DESCRIPTION: Ltr re our 6-13-75....trans the following: <u>DIST PER LA WILSON</u>	ENCLOSURES: Info concerning secondary system fluid flow instability in the Diablo Canyon design.... (15 cys encl rec'd)
PLANT NAME: Diablo Canyon 1 & 2

Diablo Canyon Units 1 and 2

Secondary System Fluid Flow Instability

Information Requested By NRC Letter Dated June 13, 1975

PIPING ISOMETRIC DIAGRAM
AUXILIARY FEEDWATER SUPPLY
STEAM GENERATORS 1-3 & 1-4

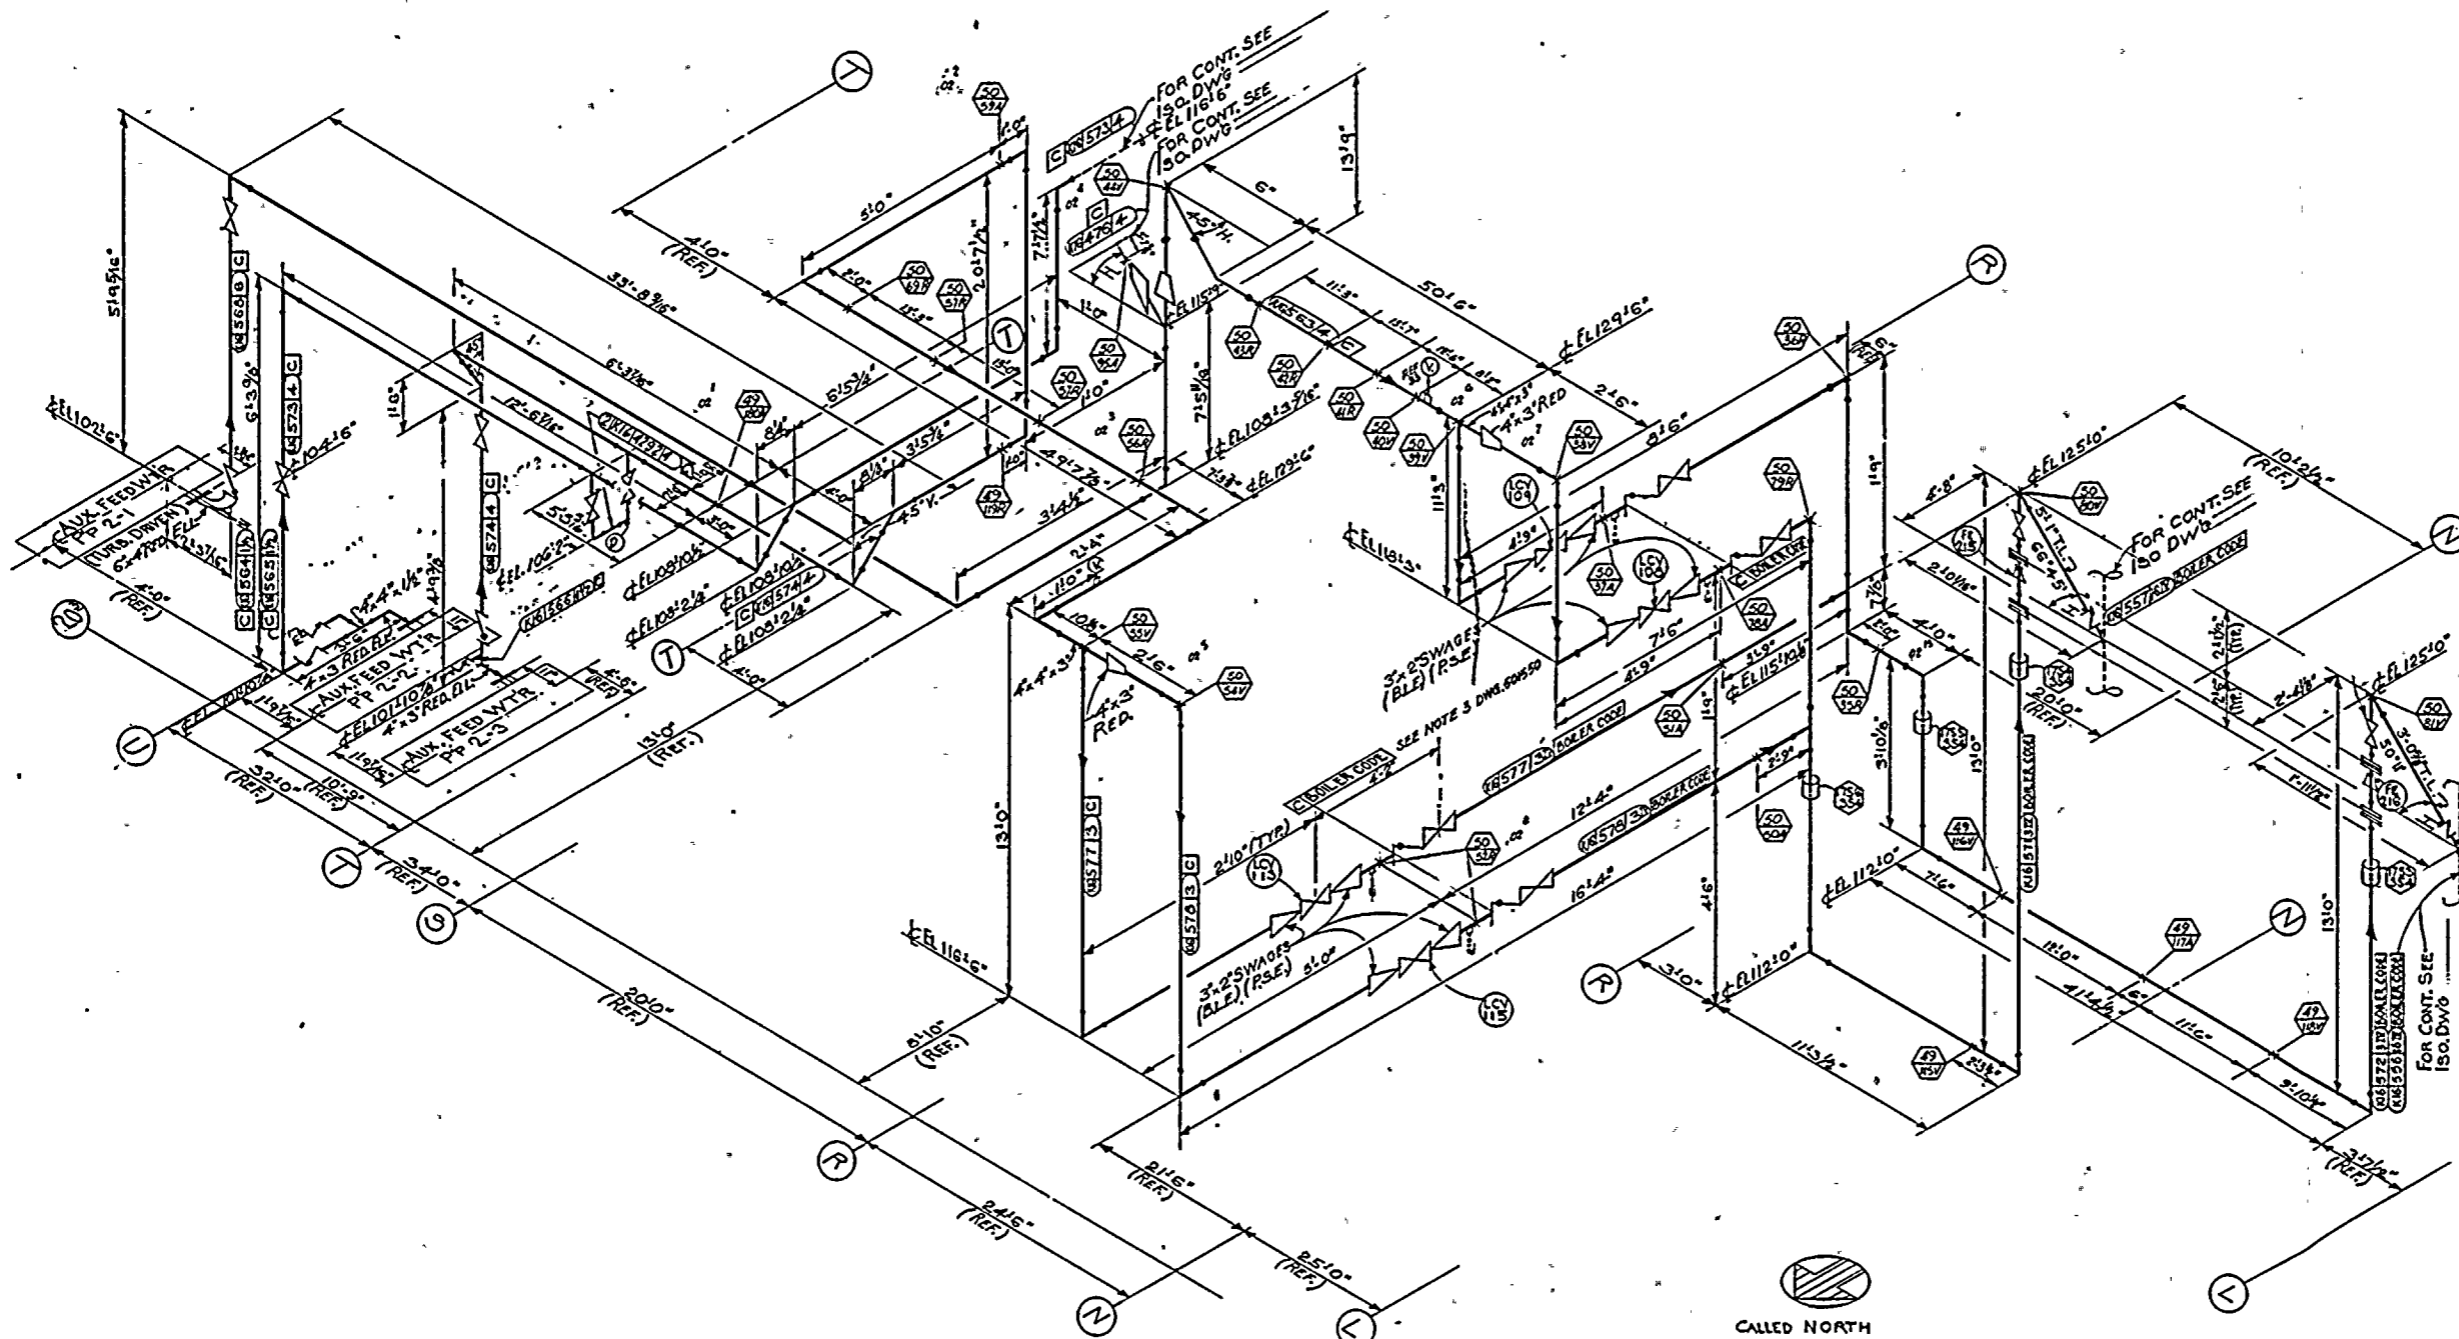
Question 2. Describe and show by isometric diagrams, the routing of the main and auxiliary feedwater piping from the steam generators outwards through containment up to the outer isolation valve and restraint. When describing the piping run, note all valves and reference continually, the elevation of the inlet nozzles and/or sparger with respect to the piping run elevation.

The Unit 1 steam generator 1-3 auxiliary feedwater line has a 5 foot 0 inch horizontal run, which contains a check valve, at elevation 125'-0", 29 feet 4 inches below the steam generator feedwater nozzle, where it leaves the feedwater line. It turns vertically downward and passes thru a manual gate valve which is the isolation valve.

The Unit 1 steam generator 1-4 auxiliary feedwater line runs 3 feet 3 inches horizontally after leaving the feedwater line at elevation 125'-0", 29 feet 4 inches below the steam generator feedwater nozzle. This run contains a check valve. The line turns vertically downward and encounters a manual gate valve which is the isolation valve.

FIGURE 10.4-4A
REVISION OF STEAM GENERATOR
FEEDWATER PIPING
STEAM GENERATORS 1 AND 4

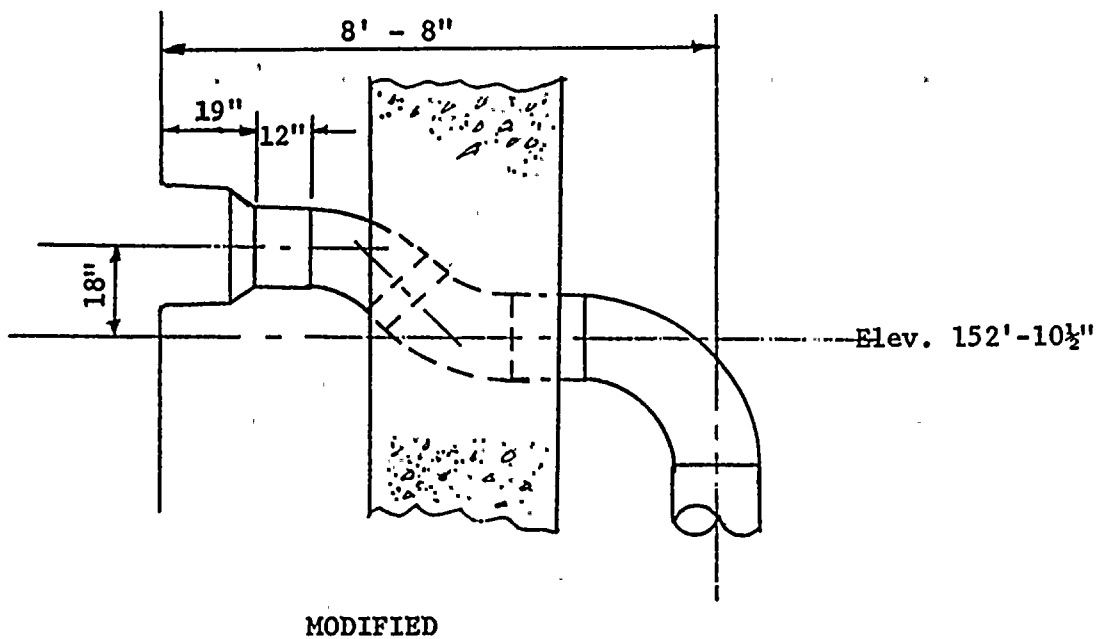
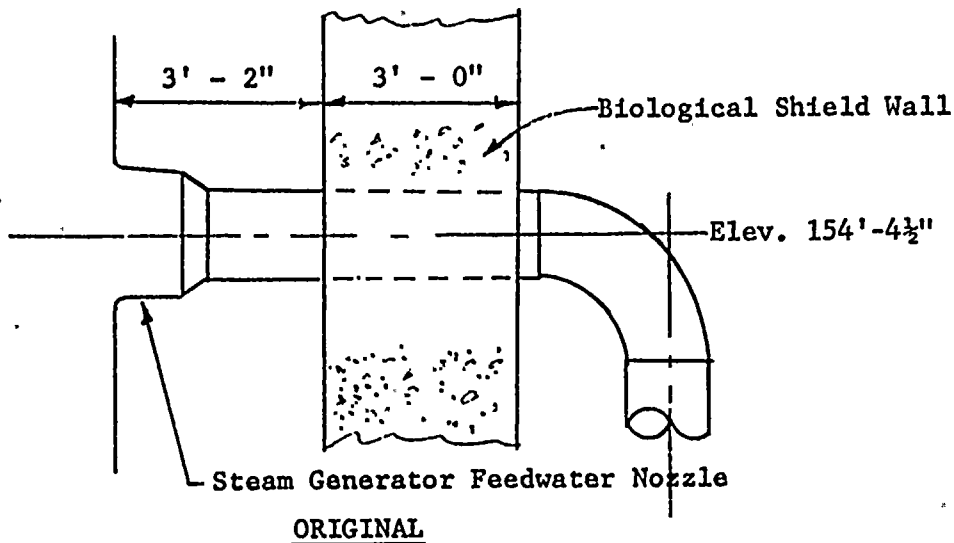
Question 5. If plant system design changes are to be made to preclude the occurrence of flow instabilities, describe these changes or modifications, and discuss the reasons that made this alternative

(All the feedwater piping described to this point is illustrated in Figures 10.4-4 A and B of the FSAR which are attached). All feedwater lines continue vertically downward until they reach a nominal elevation of 129'-0", which is 25 feet 4 inches below the steam generator nozzles. At this elevation, they turn horizontally and run 21 feet 7 inches at which point they attach to the flued heads of the containment penetrations and are anchored. They continue, passing thru the containment. The horizontal runs at this elevation vary from approximately 34 to 37 feet long. These horizontal runs are 18°-28' or 21°-05' out of the vertical planes of the horizontal runs previously described (see isometric drawings for exact dimensions). In these horizontal runs, outside the containment, the lines to steam generators 1 and 2 have auxiliary feedwater nozzles and then motor operated isolation gate valves. These are the outer isolation valves for these two lines. All lines turn downward and run from approximately 9 to 17 feet vertically (see isometric drawings for exact dimensions). In these vertical runs, the lines to steam generators 3 and 4 have auxiliary feedwater nozzles. All lines turn horizontally, at elevations varying from 119'-5" to 112'-6", that is, from 35 to 42 feet below the steam generator nozzles. The lines to steam generators 3 and 4 have motor operated isolation gate valves immediately after they make this horizontal turn. These are the outer isolation valves for these two lines. All four feedwater lines (for each unit) eventually join together and run thru the number 1 feedwater heaters to the feedwater pumps.

The steam generator feedwater piping has been modified to minimize the length of horizontal piping which could be drained when the steam generator water level is below the feedwater distribution ring. This modification consisted of installing two 45° elbows in such a manner as to create a water trap and is illustrated in FSAR Figures 10.4-4A and 4B, copies of which are attached. Experience with steam generator feedwater line water hammer at other plants and the calculational model discussed under Question 3 have indicated that a short length of piping adjacent to the steam generator has the effect of reducing the intensity of the possible water hammer. This alternative for shortening the line is superior to other alternatives that might have been applied because it used material available without a delay and because it obtained the desired result with the minimum installation cost and with the lowest possible added permanent pressure loss in the feedwater lines. This alternative also required the minimum revision of concrete in the crane walls, which had been erected before the need for a design modification had become apparent.
